| SYSTEM | ADVANCED LIGO |
| PART NAME | BLADE TIP STOP MOUNT BS TOP STAGE |
| DRG. NO. | D080090 |

SECTION A-A

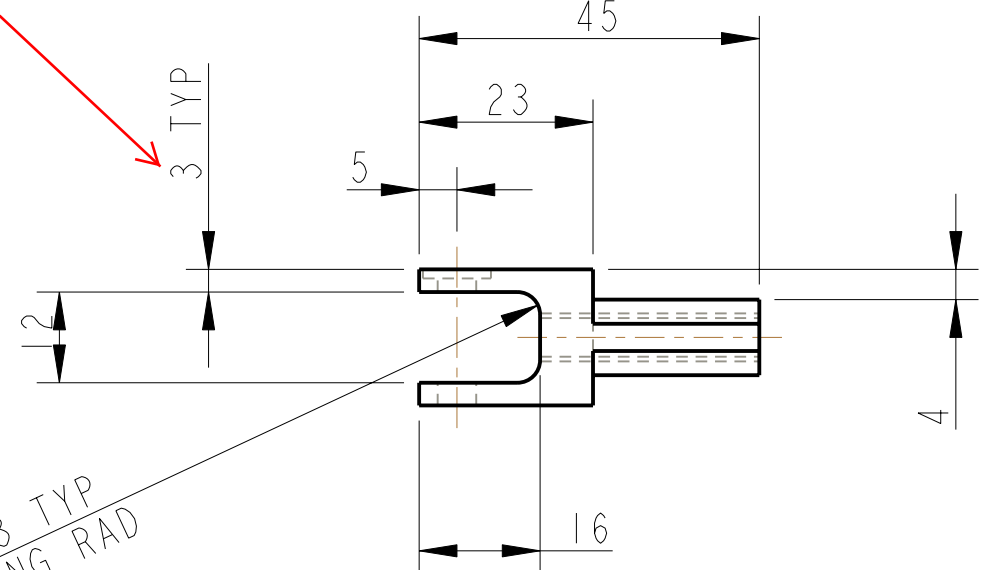
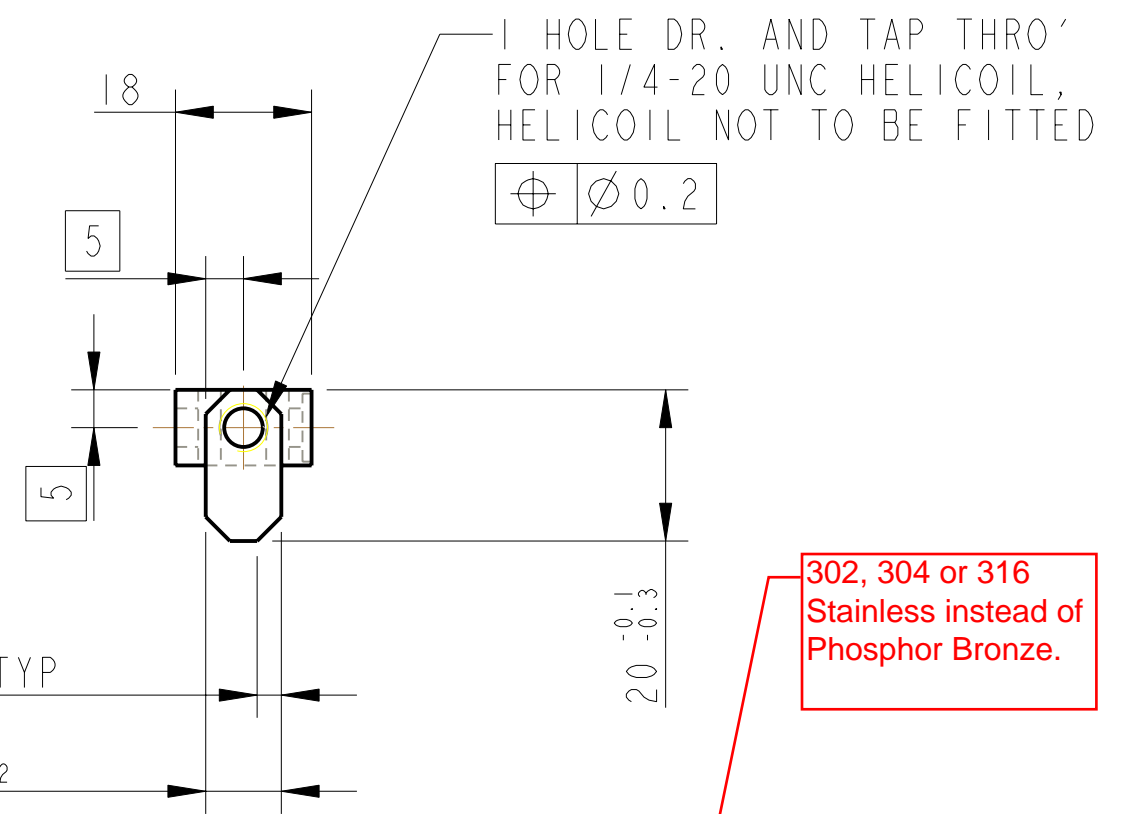
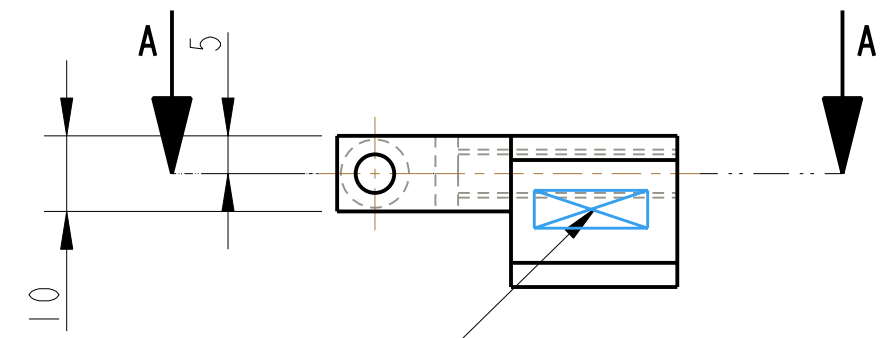
Change from 3mm TYP to 2.2mm TYP

Change from 12mm to 13.6mm

R3 TYP
MAX TOOLING RAD

302, 304 or 316 Stainless instead of Phosphor Bronze.
